Reg. No.: P1186-02

Regulation 10(2)(b)(ii) of the EPA (Industrial Emissions) (Licensing) Regulations 2013, in respect of a licence review from Amazon Data Services Ireland Limited for an installation located at Clonshaugh Business and Technology Park, Dublin 17.

REGULATION 9 COMPLIANCE REQUIREMENTS

Foul water drawing

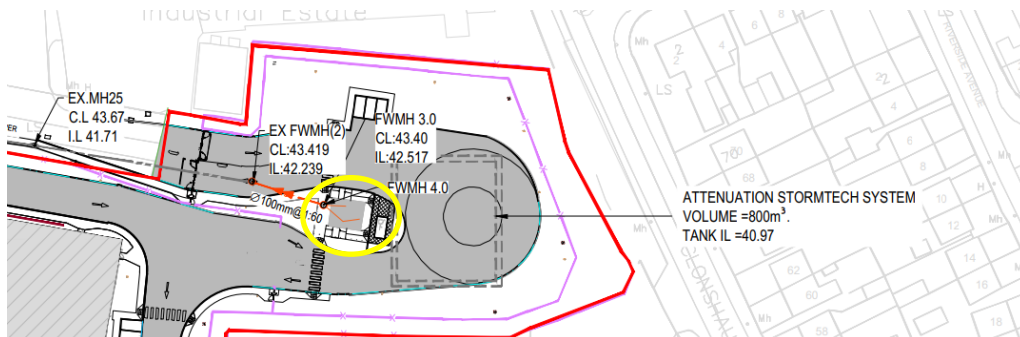
1. Provide a more detailed site layout plan. **Example** of detail required: the screen shot taken from the foul water layout plan (Drawing: 21_123F-CSE-00-XX-DR-C-1200) below shows foul water from an area adjacent to the attenuation storm cell (yellow circle has been added to show this area), however the site layout plan (Drawing: 21_123F-CSE-00-XX-DR-C-0002) (see screen shot below) does not identify this area.
